Access Compliance Report Public Rights-of-Way (RR Crossings)

Intersection ID: 10031407	Main Street: MCALPINE_STATION_DR	Location: N/A
ADA ID: FC175BB784C0	Overall Compliance: No	Severity Score: 0.0
Codes/Mitigation Info/Possible Solution		Field Measurements/Component Compliance

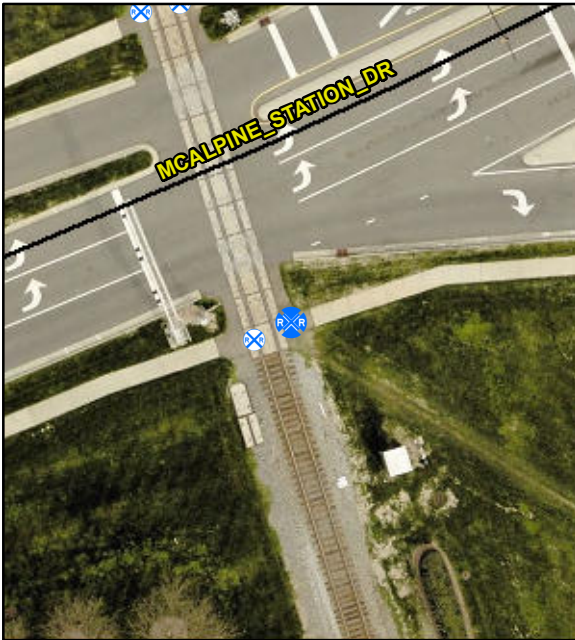
Compliance	Description	Data
No	DWS Provided?	No
N/A	DWS Contrast?	No
N/A	DWS Width (in)	No
N/A	DWS Length (in)	N/A
N/A	DWS Offset (in)	N/A
No	Pedestrian Gate?	No
N/A	DWS Outside Gate?	No
N/A	Rail Type?	Freight
No	Flangeway Gap (in)	3.0
Yes	Sidewalk Width (in)	60.0

**Install Detectable Warning System.
Provide Pedestrian Gate. Remove &
Replace Walking Surface Adjacent
to Rail.**

R208.1, R302.7.4, R305.2.5
